ORIGINATION FORM

Proposed Revisions to a Standard Plans Index
(Please provide all information — Incomplete forms will be returned)

Index Number: 455-031
Sheet Number (s): 1 of 1
Index Title: 30" SQUARE PRESTRESSED CONCRETE PILE -
HIGH MOMENT CAPACITY

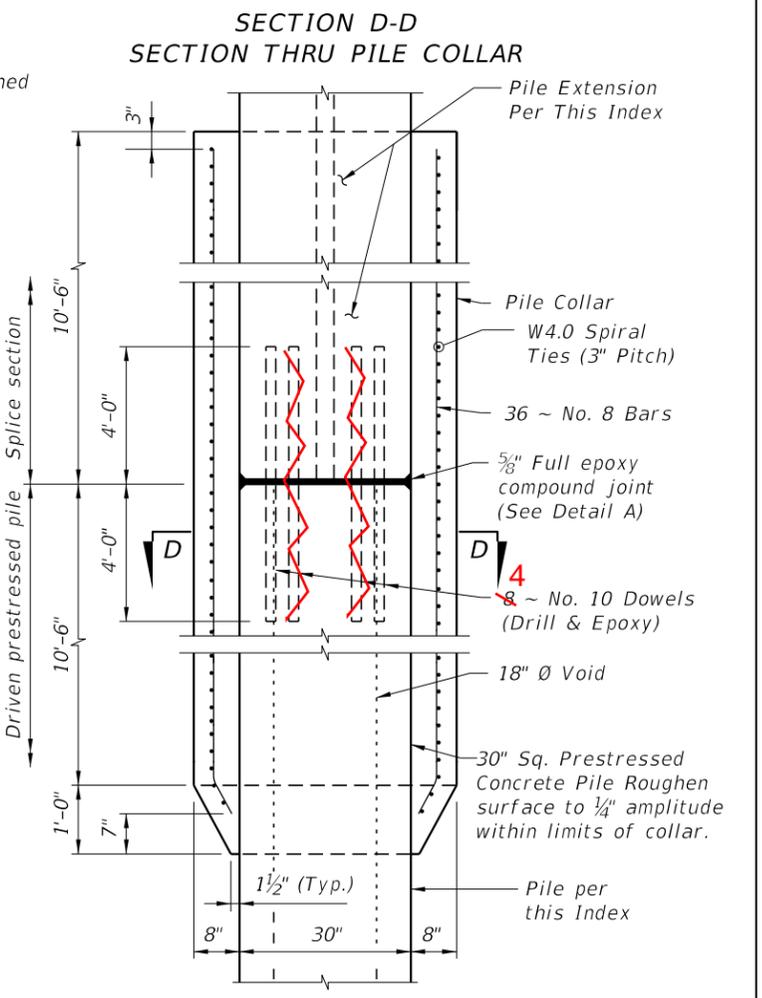
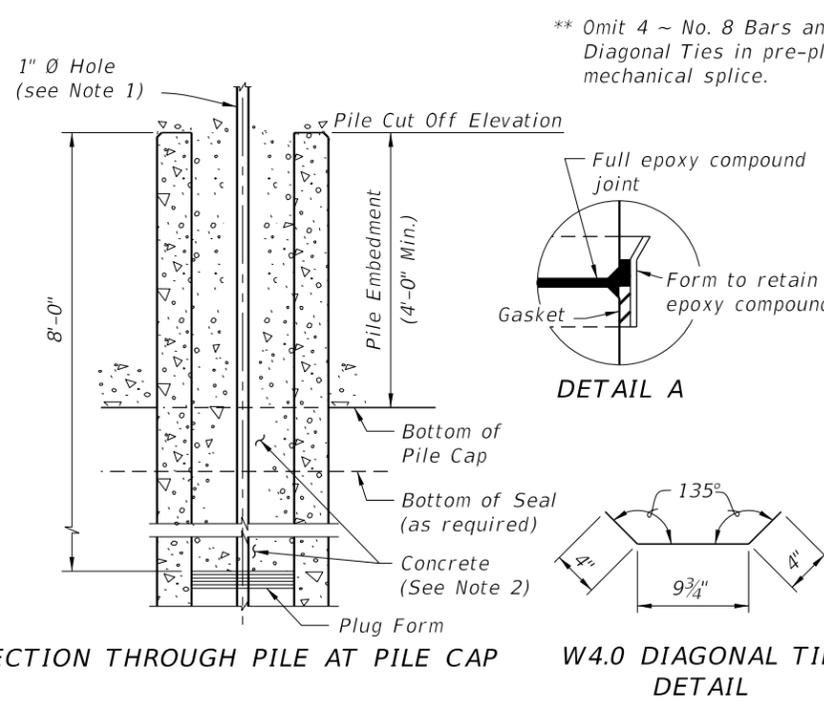
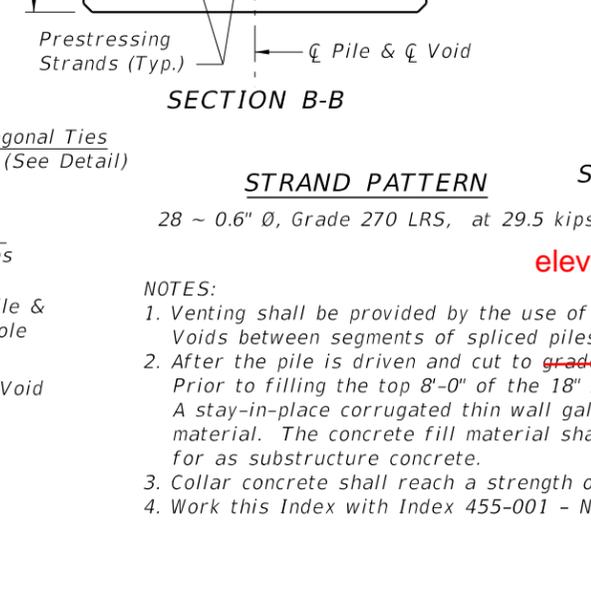
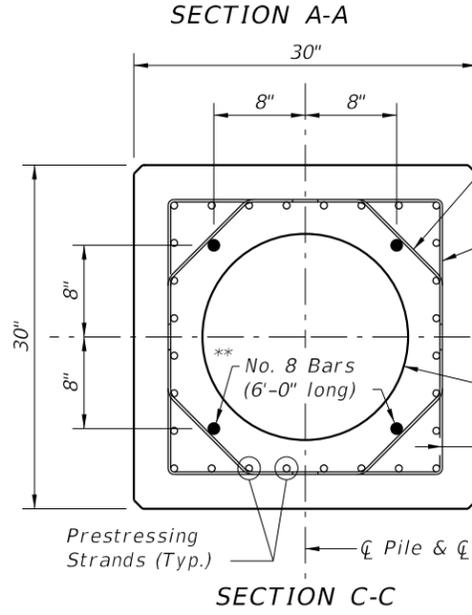
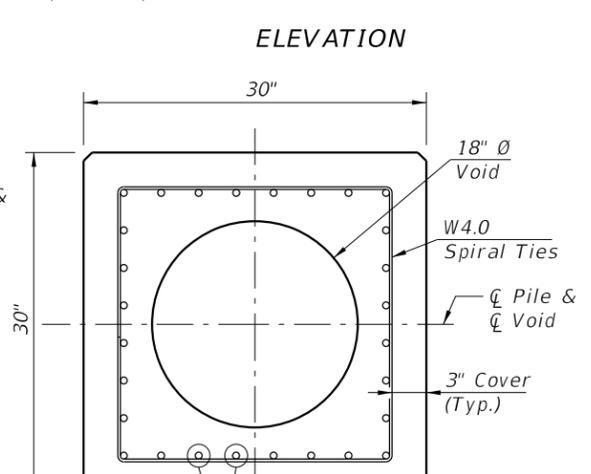
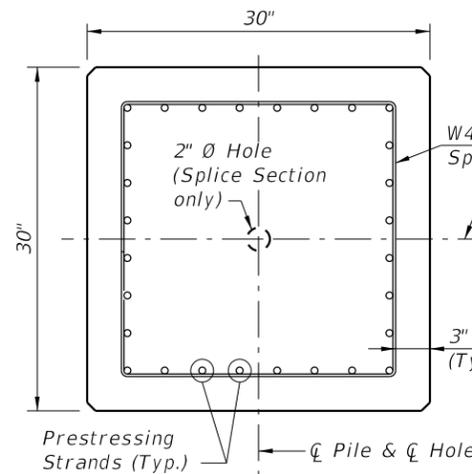
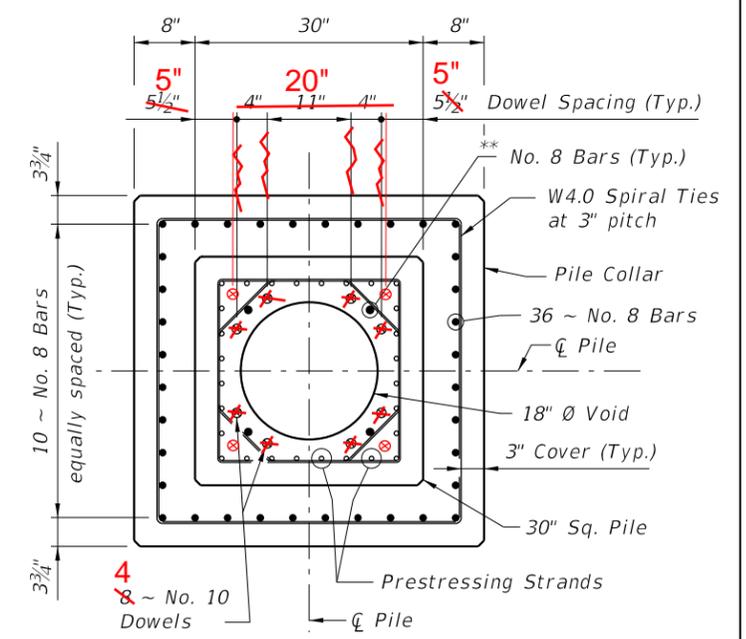
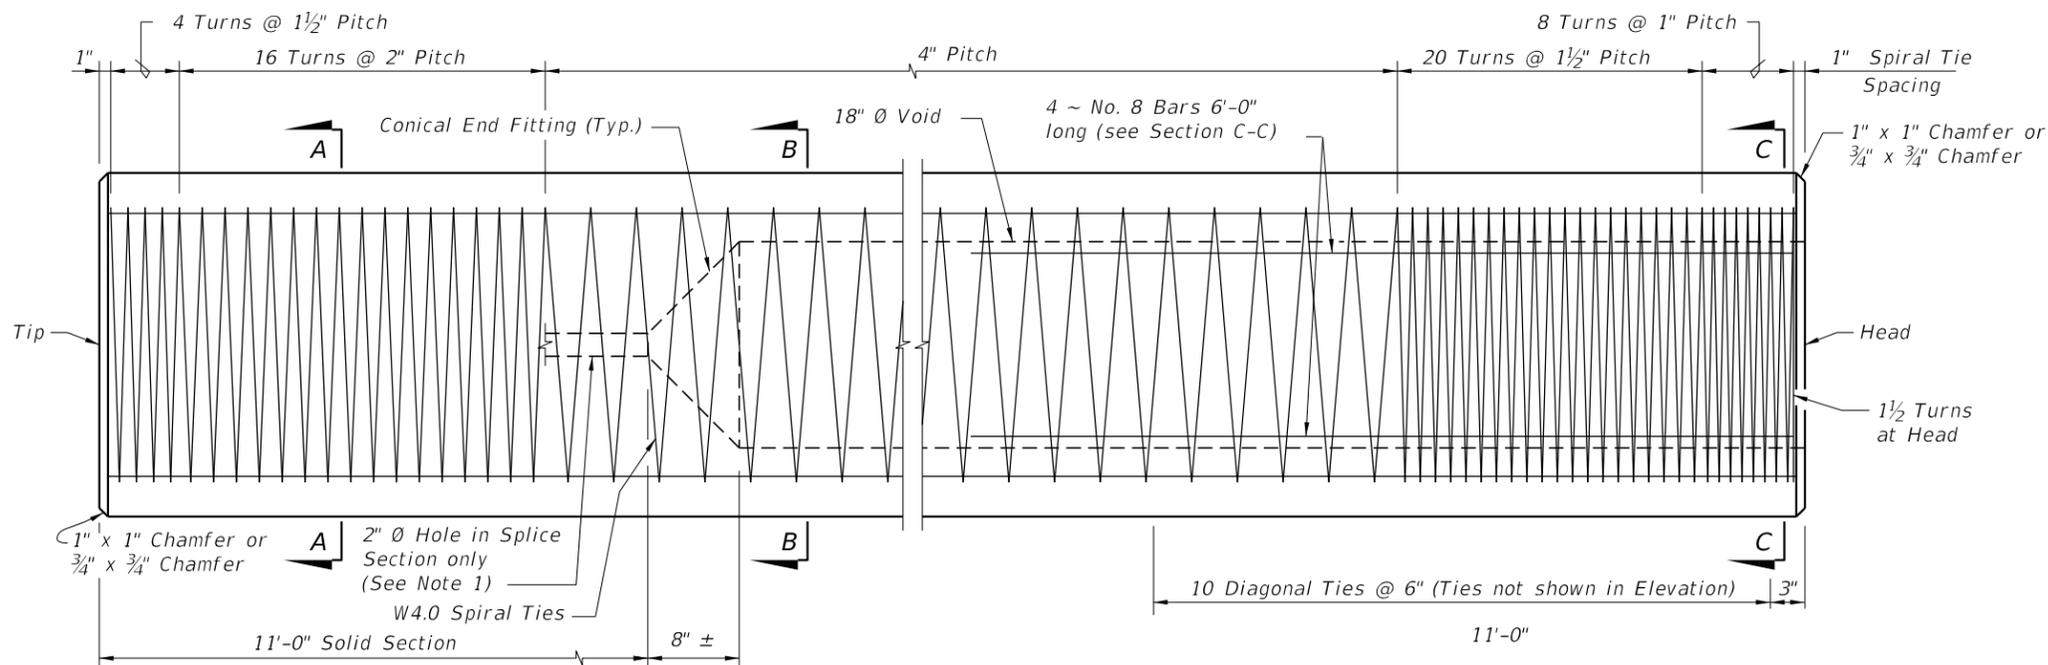
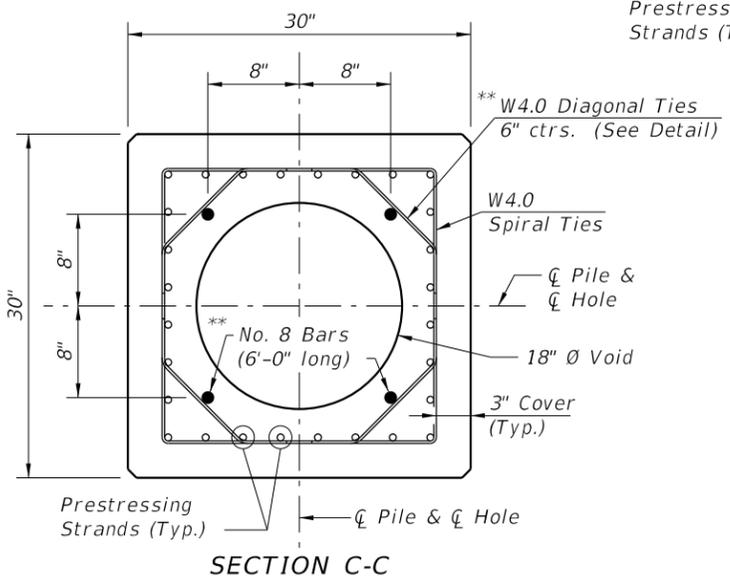
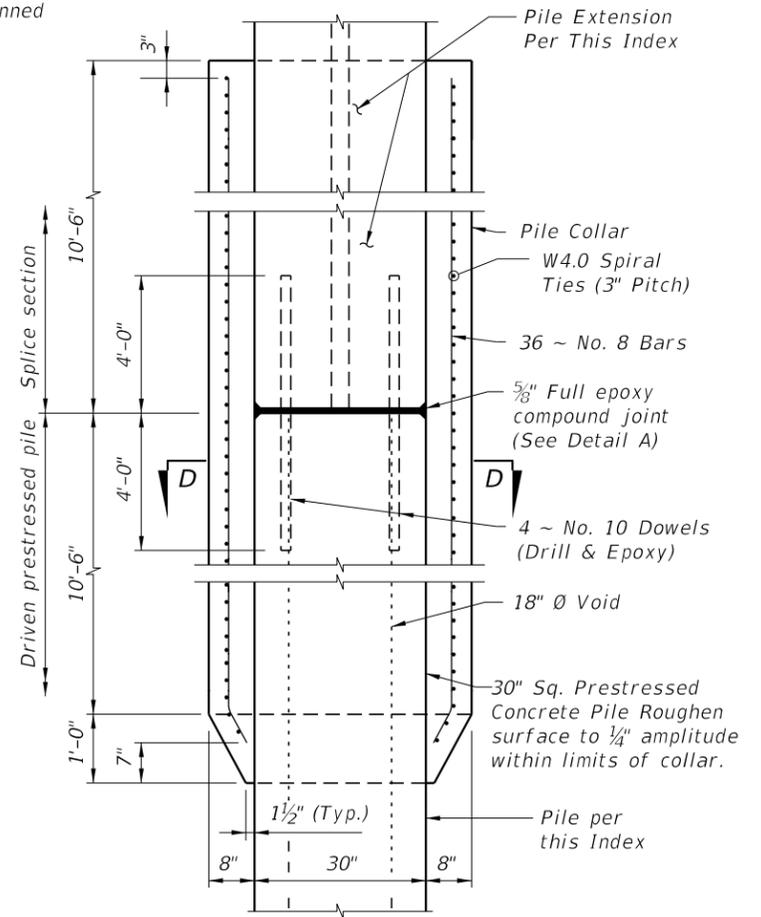
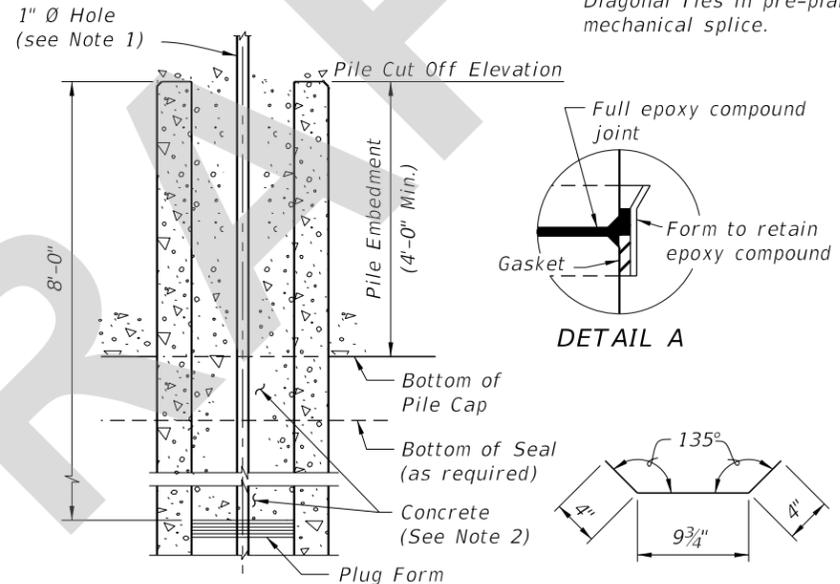
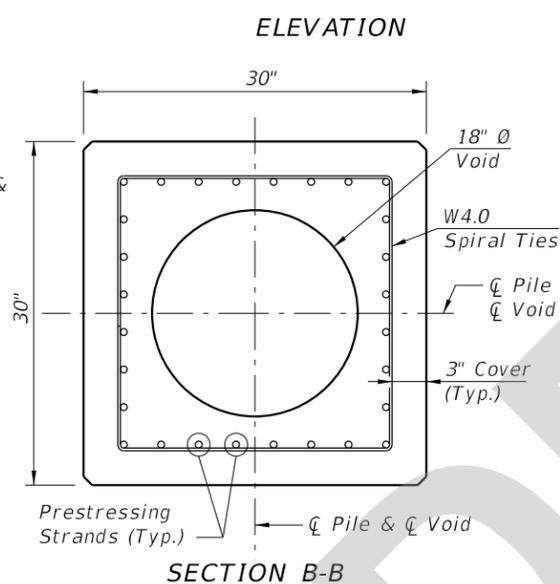
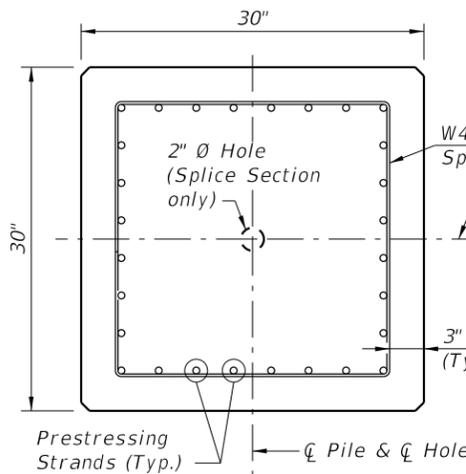
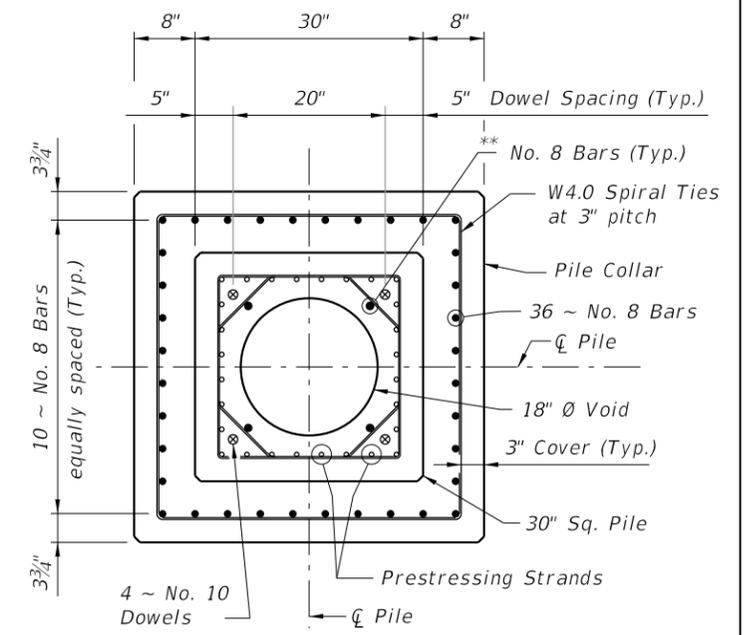
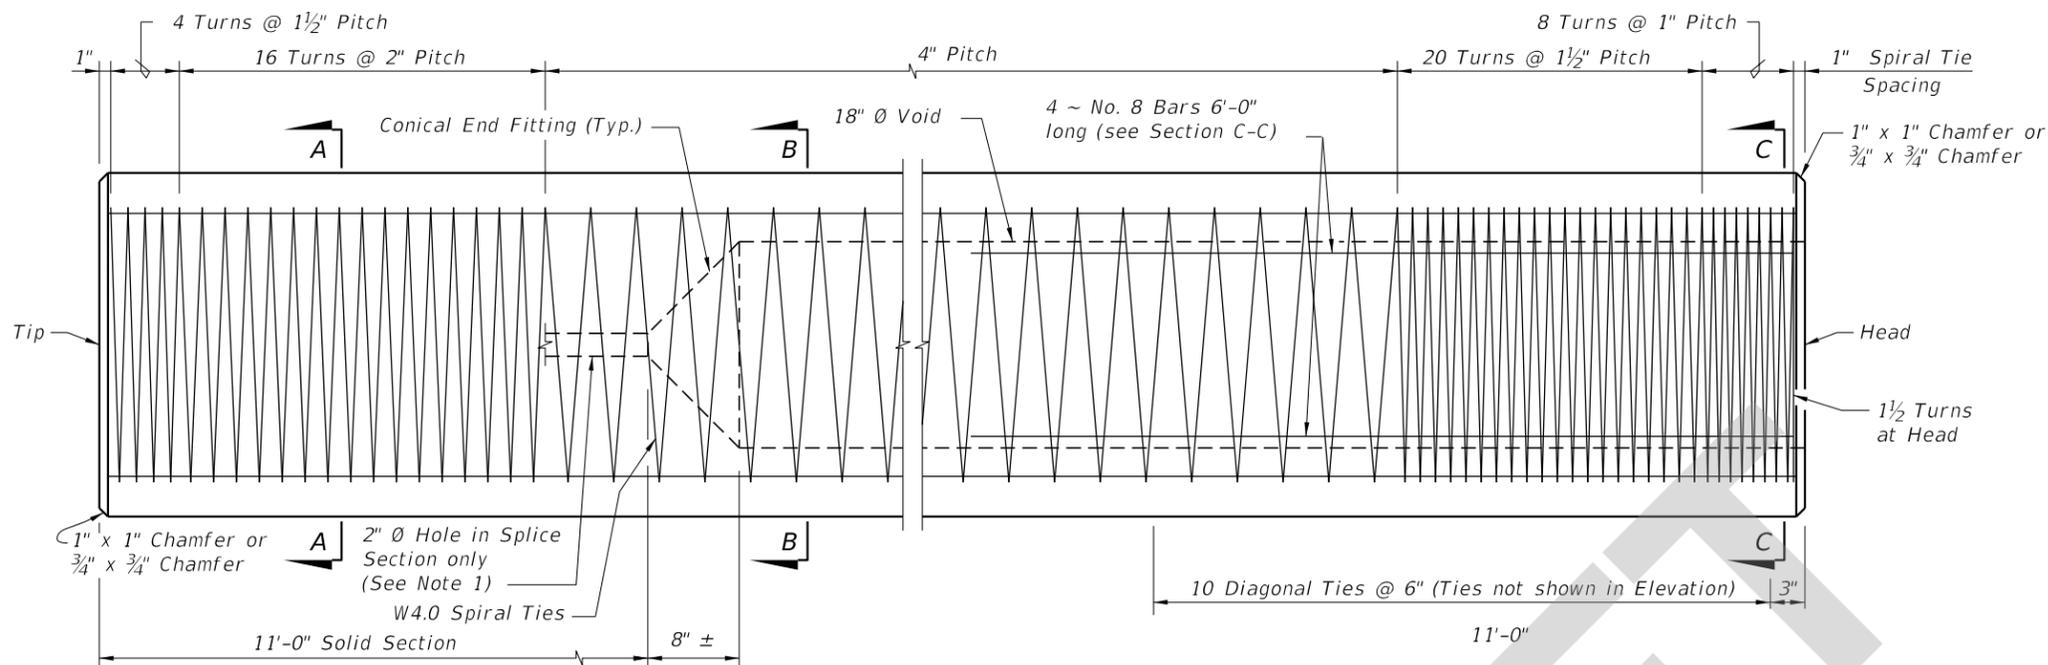
Sheet 1: Changed the location of the dowels; Deleted part of note 2 not allowing for corrugated galvanized metal pipe forms.

The location of drilled holes for the #10 dowels that are epoxied into the voided end for the splice connection are extremely close to the face of the void and will spall during drilling (1-3/4" drill bit).

These dowel bars should be moved further inside the pile wall, but the only place to avoid other reinforcing is inside the corner of the strand pattern (see the blue circle in the markup below). This would reduce the total number of dowel bars possible from 8 to 4, but this should be OK since almost all the moment capacity comes from the collar reinforcing (36~ #8 bars on the perimeter) recognized these extend lapped 10-feet either side of the splice joint while the #10 dowel bars only extend 4-feet and are temporary restraint and alignment while the exterior collar is constructed. -- Steve Nolan

For the metal pipe forms it was decided that the forms would create a corrosion risk and reduce the possible lifespan of the pile. Therefore, this allowance was removed.
